# Addendum Report to the Section 42A Hearing Report for Proposed Plan Change 5: Whenuapai Plan Change

**Date:** 30 April 2018

Subject: Proposed Plan Change 5: Whenuapai Plan Change

Report Author: Anne Bradbury, Principal Planner, North West and Islands Planning

### Removal of the permanent stream on 12 Sinton Road

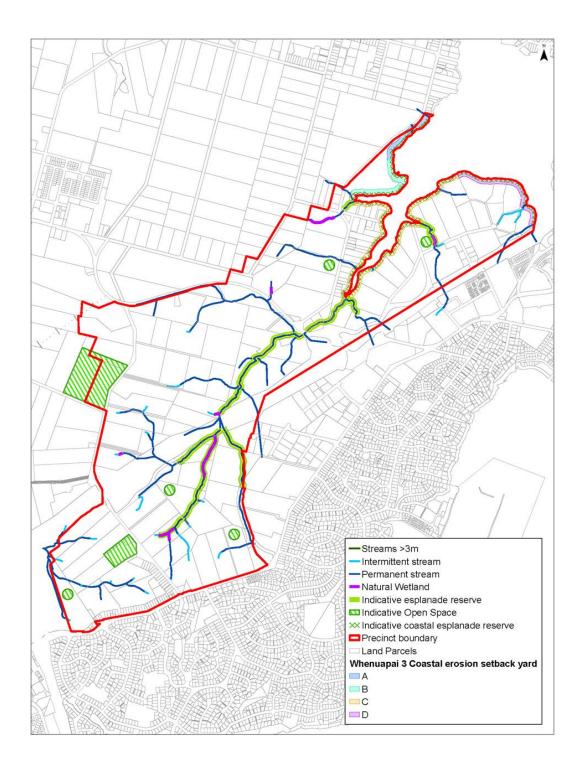
- 64. A statement of evidence was received from Evita Key on behalf of GRP Management Limited, submitter 26. Ms Key's evidence relates to amending Whenuapai 3 Precinct Plan 1 to remove the notation of the permanent stream from 12 Sinton Road.

69. After reviewing Ms Key's evidence, I agree with the submitter's suggested amendment to the Whenuapai 3 Precinct Plan 1. This amendment can be seen below and in Appendix 3.

## 1616.10.1. Whenuapai 3 Precinct Pan 1

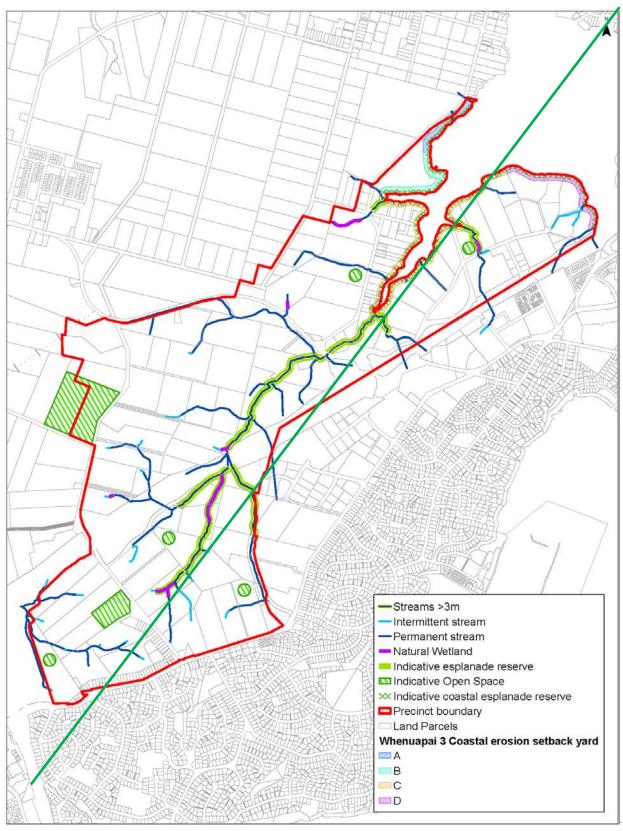
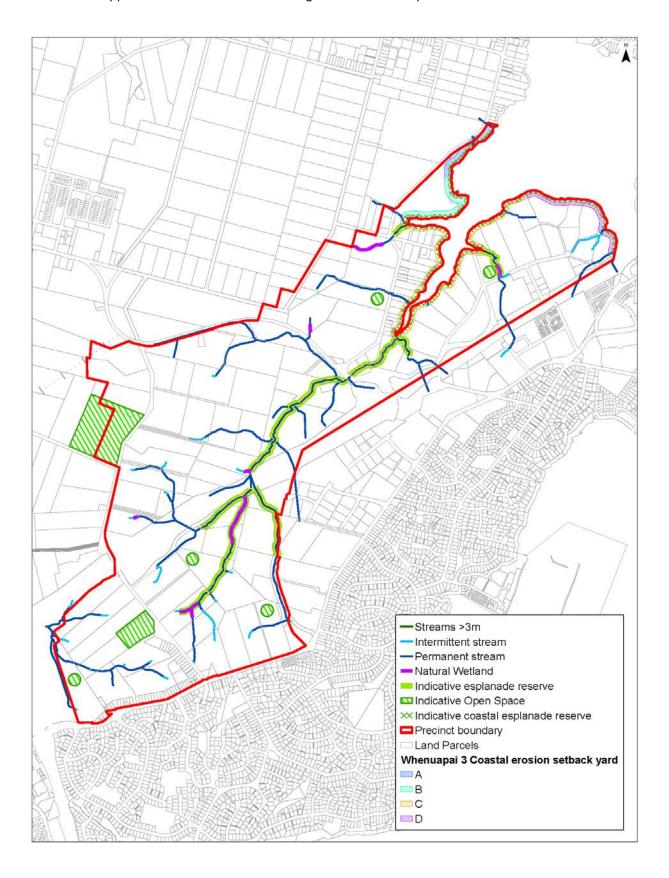
- 4.2 Healthy Waters has reviewed the information provided and its own watercource assessments and concludes that the stream located along the western boundary of 12 Sinton Road, Hobsonville, is incorrectly identified as a permanent stream in I616.10.1 Whenuapai 3 Precinct Plan 1. Healthy Waters agree this is likely a farm drain.

- 4.3 Healthy Waters agree that this farm drain should be removed from I616.10.1 Whenuapai 3 Precinct Plan 1. Refer to Attachment 1 for the amendment to be made.
